AEC15-010

Re: **Environmental Impact Study Addendum #1 to LSRCA First Submission
Natural Heritage Review, 70 Pioneer Trail - Barrie (APID: 4264223)**

70 Pioneer Trail – Barrie (APID: 426223)

DATE ISSUED:	August 2022	Figure No.
CREATED BY:	JLM	2a
PROJECT NO.:	15-010	
REFERENCE:	Simcoe County

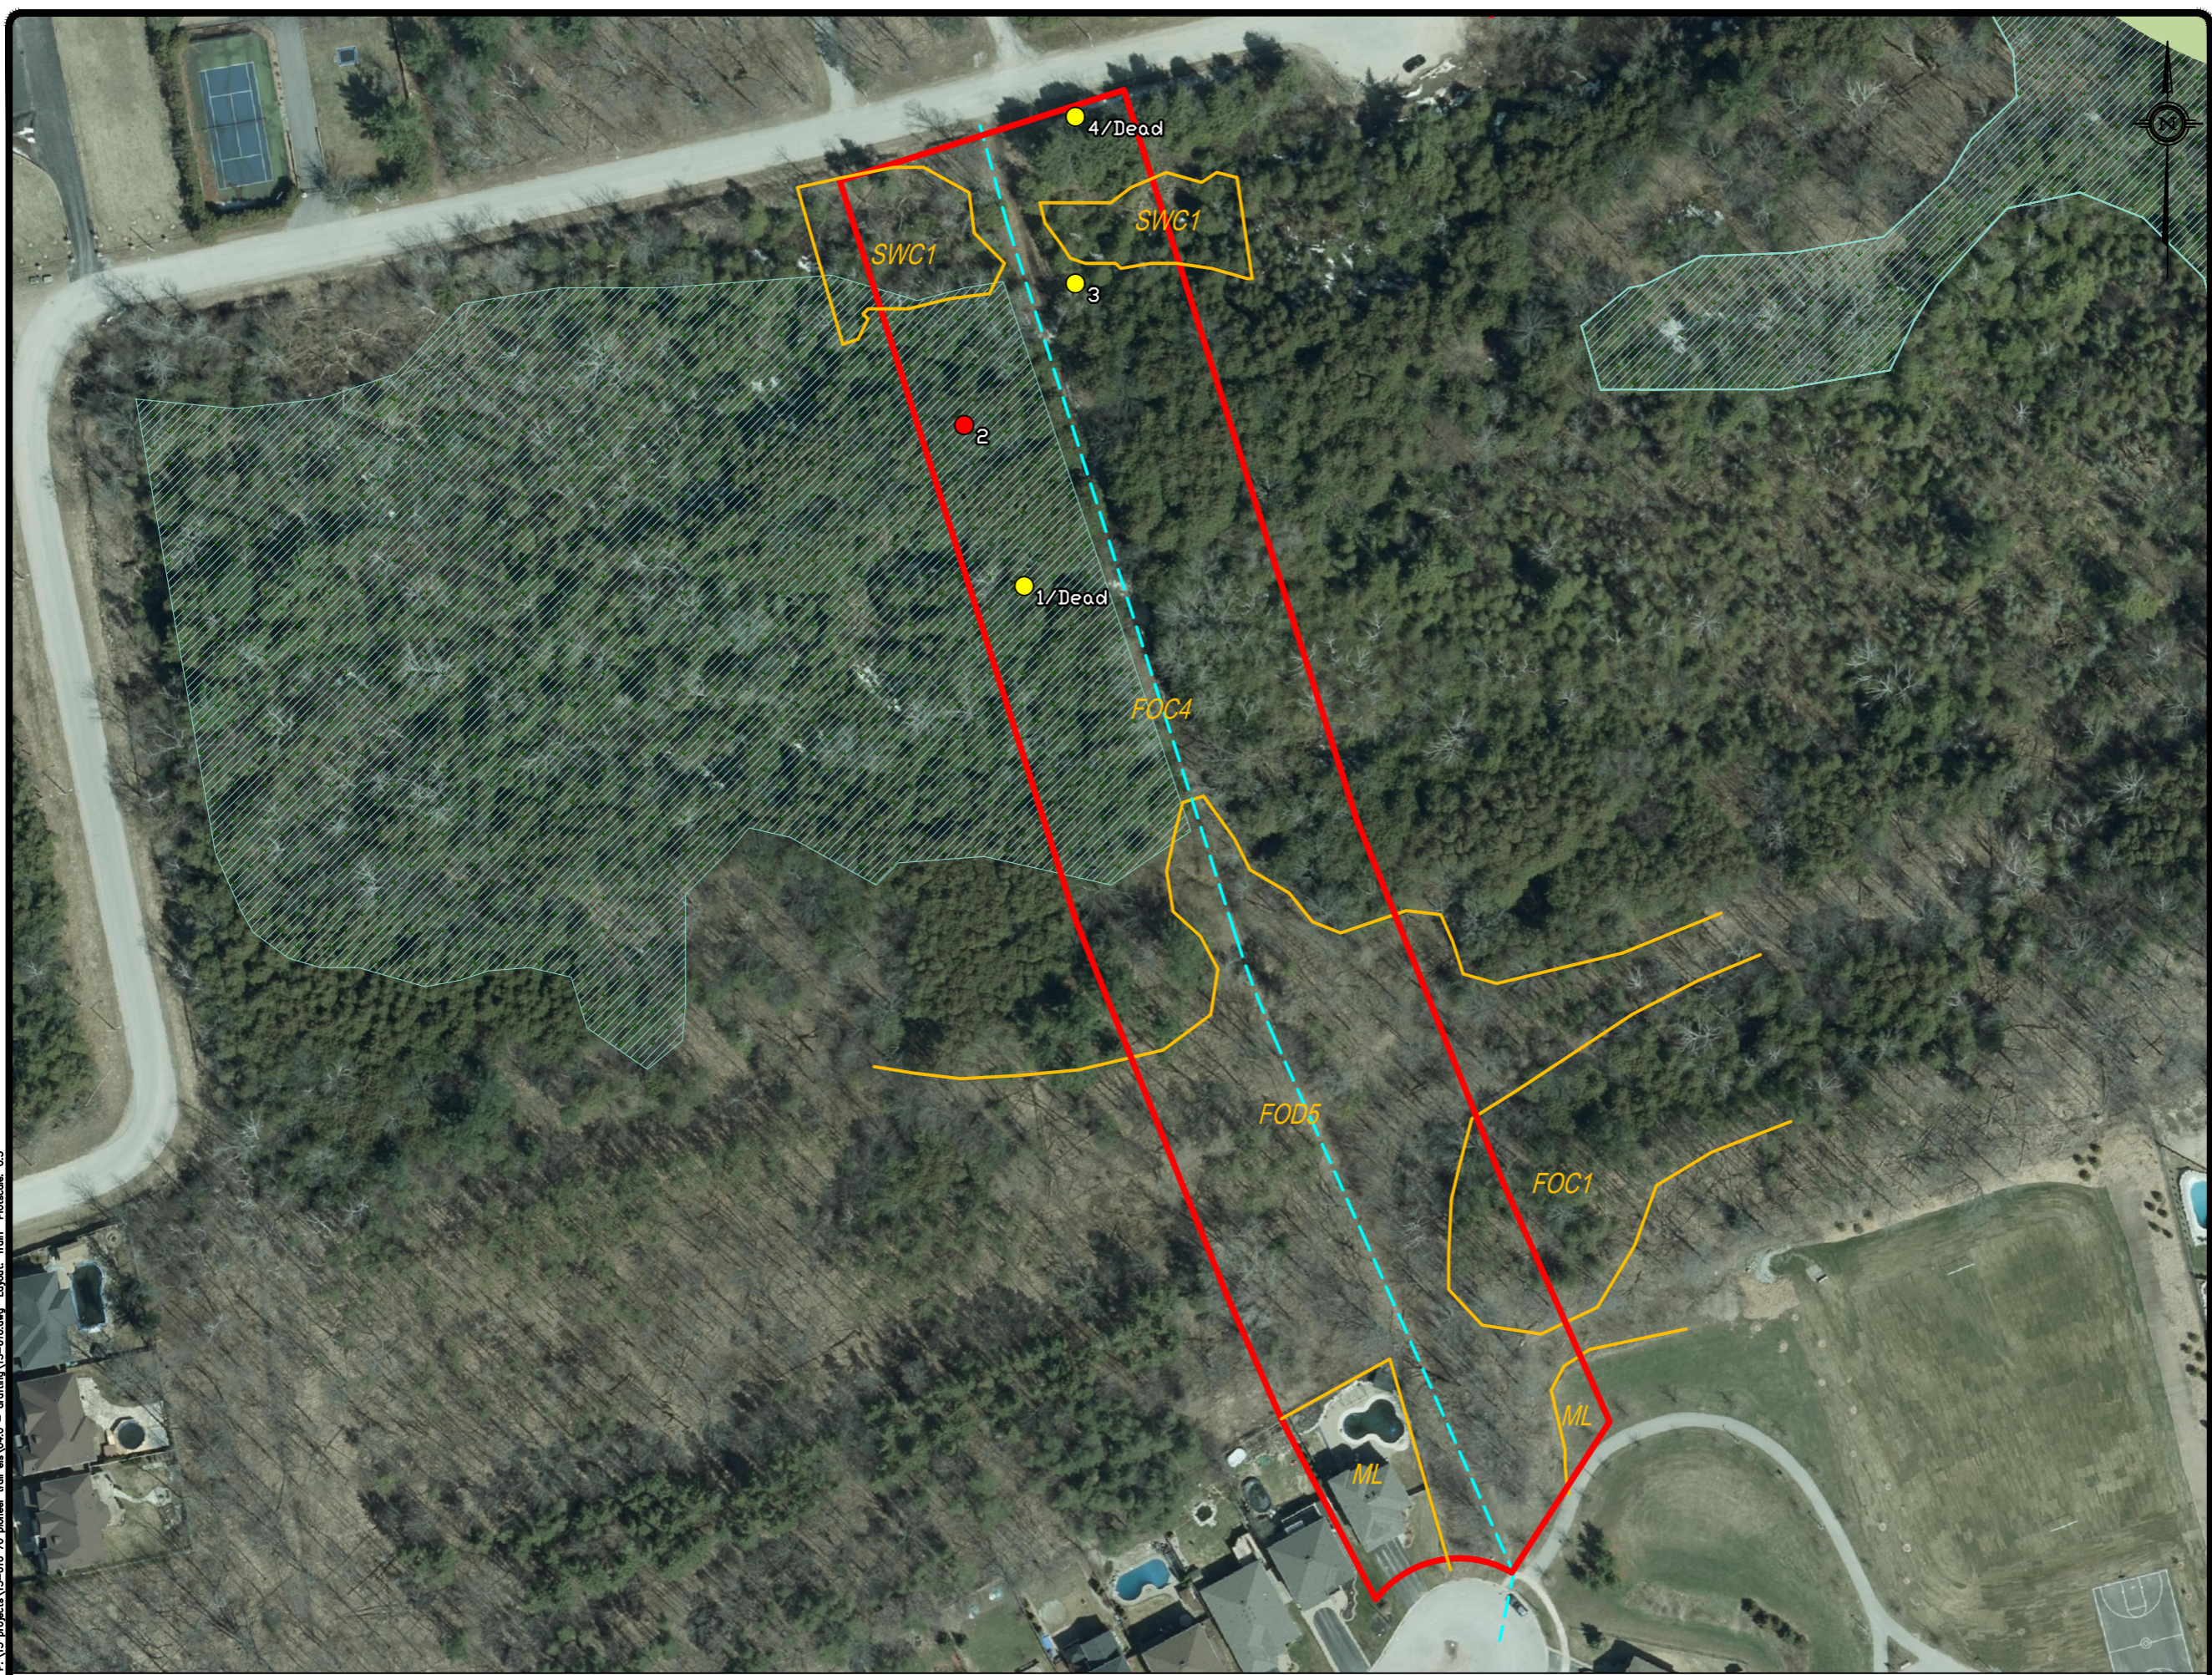
Figure 2 and Figure 3 (attached) have been updated to illustrate Unevaluated Wetlands mapped by the Ministry of Natural Resources and Forestry (MNRF).

LSRCA should note that during post-submission edge management surveys one (1) additional seedling-stage Butternut was observed in the southern portion of the property. The location of this individual has been added to Figures 2a and 3a.

DATE ISSUED: August 2022	Figure No.
CREATED BY: JLM	3a
PROJECT NO.: 15-010	
REFERENCE: Simcoe County

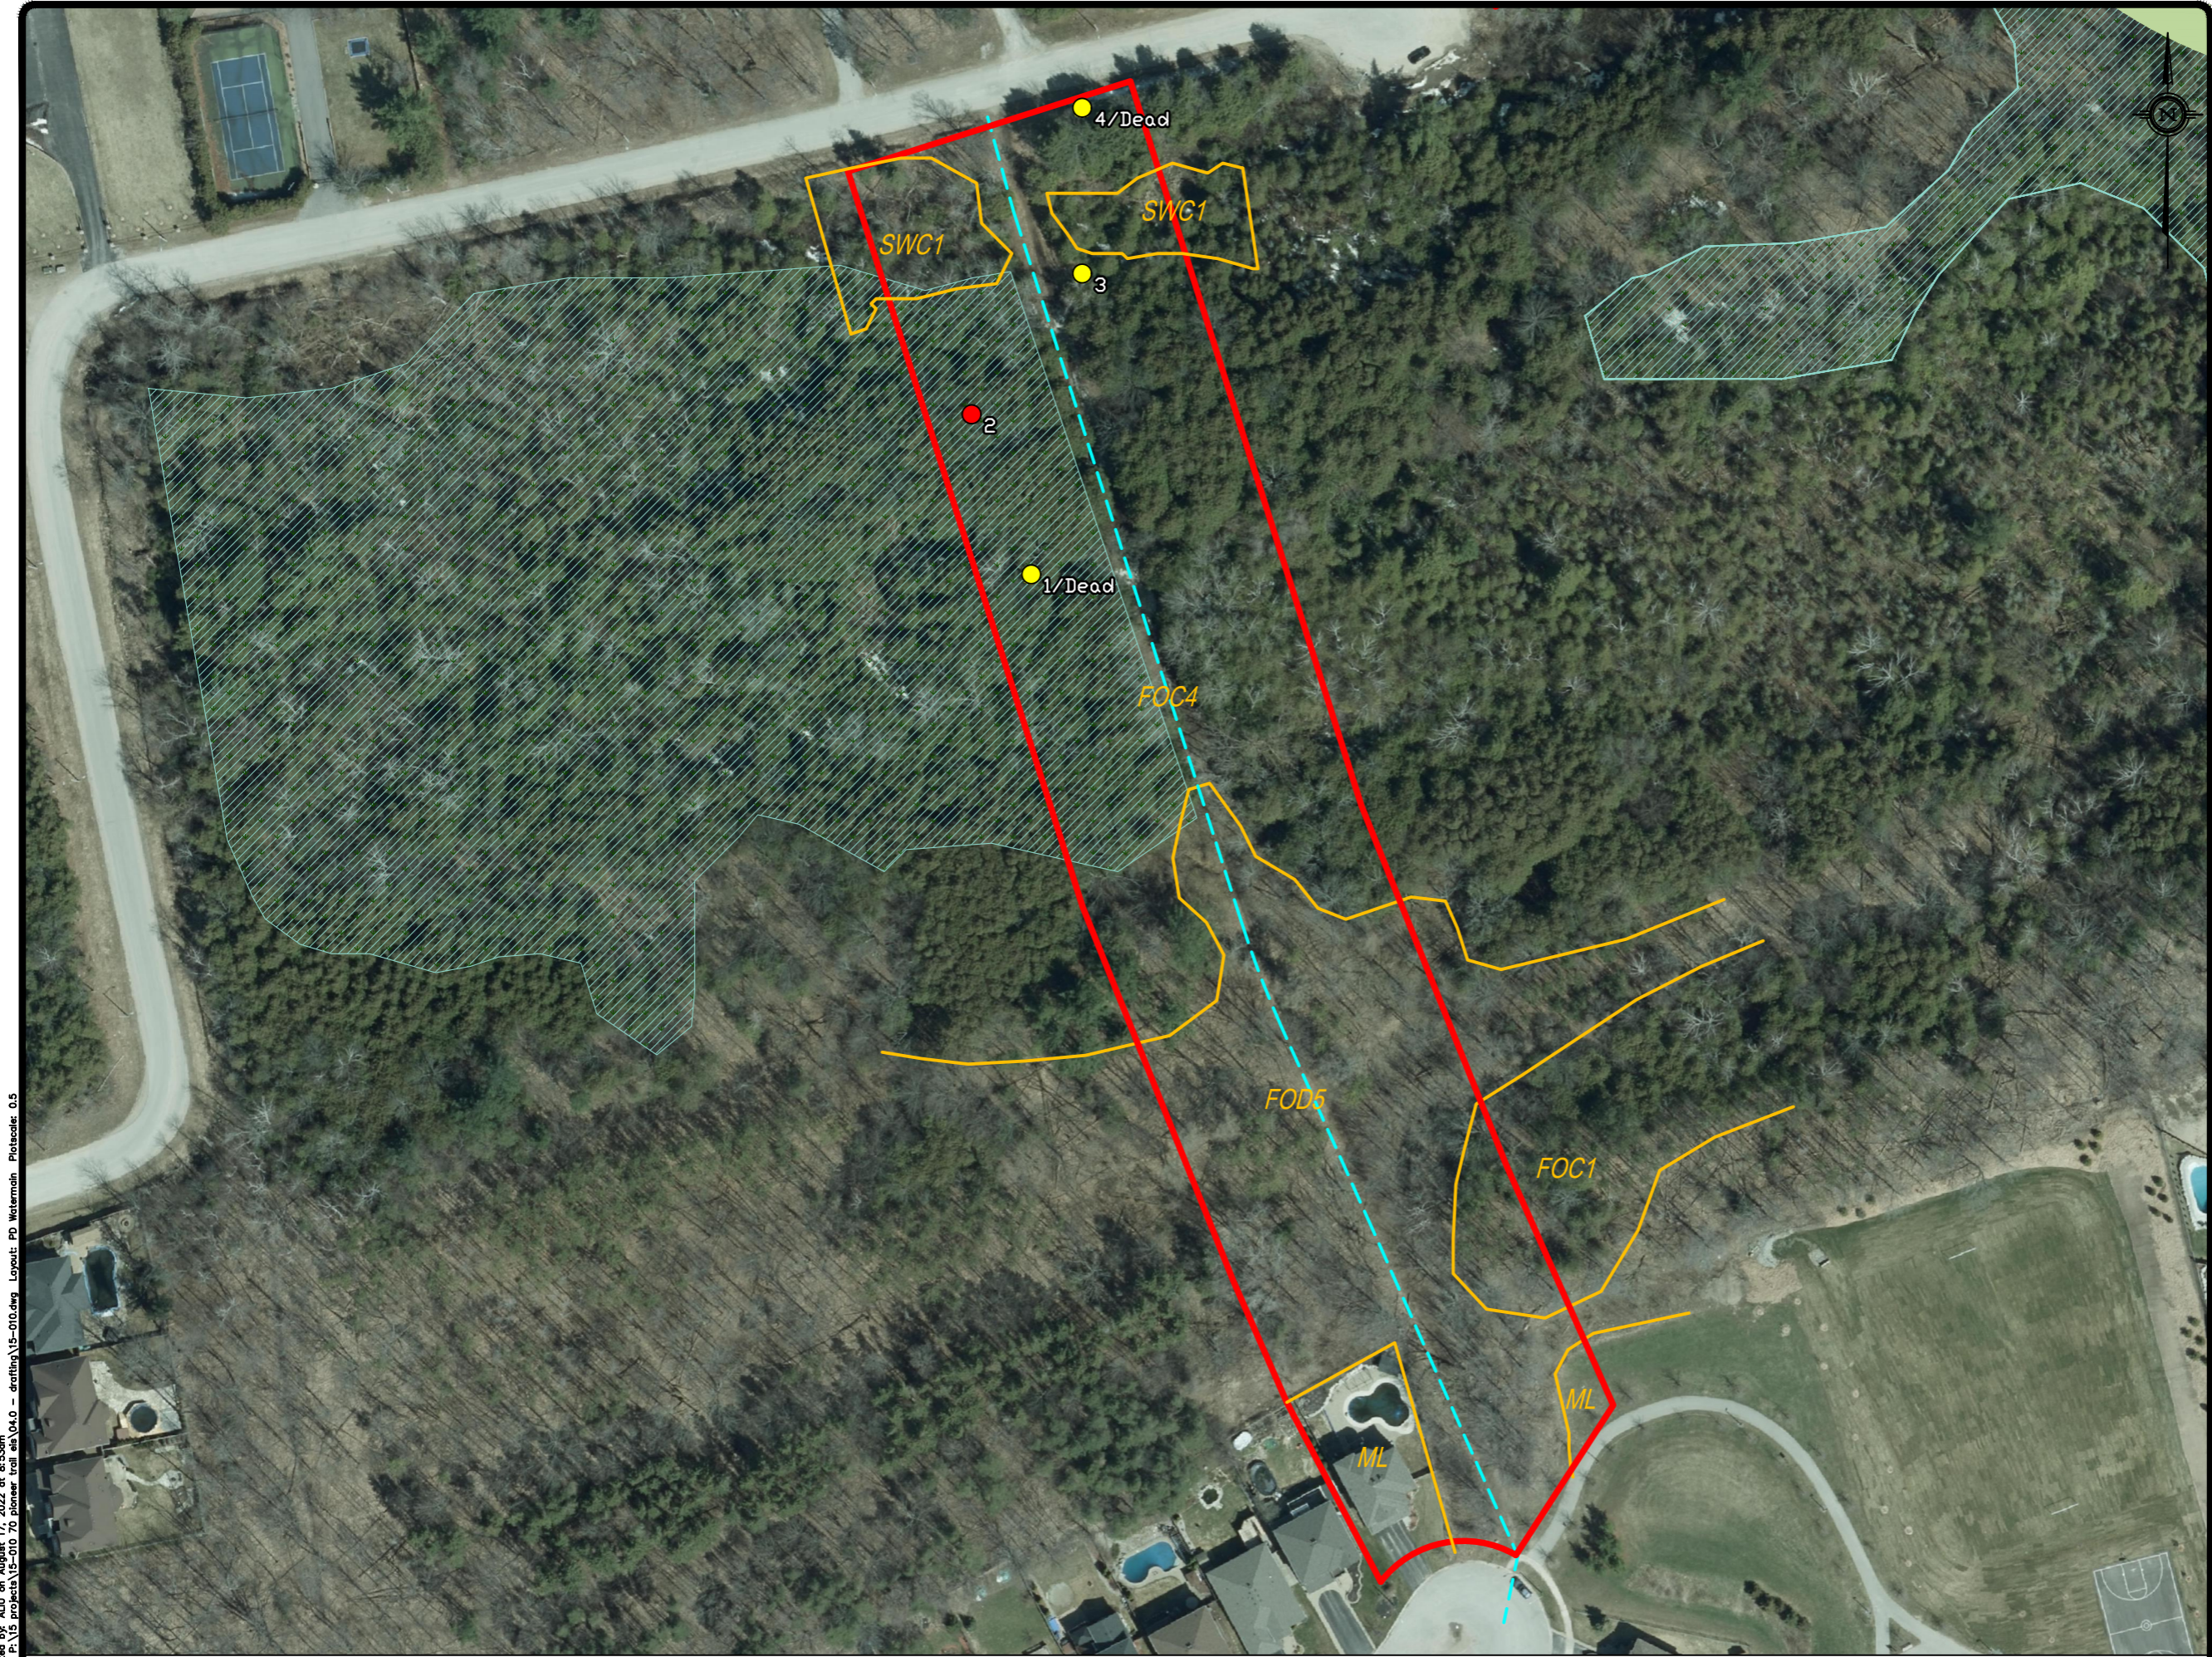
As shown in Figure 3a, direct woodland removals of 2.10ha and removals within a 5m woodland VPZ of 0.31ha will be necessary to accommodate the proposed development. Note that the direct removals calculation has been revised since the previous EIS submission (February 2, 2022) due to Grading Plan revisions.
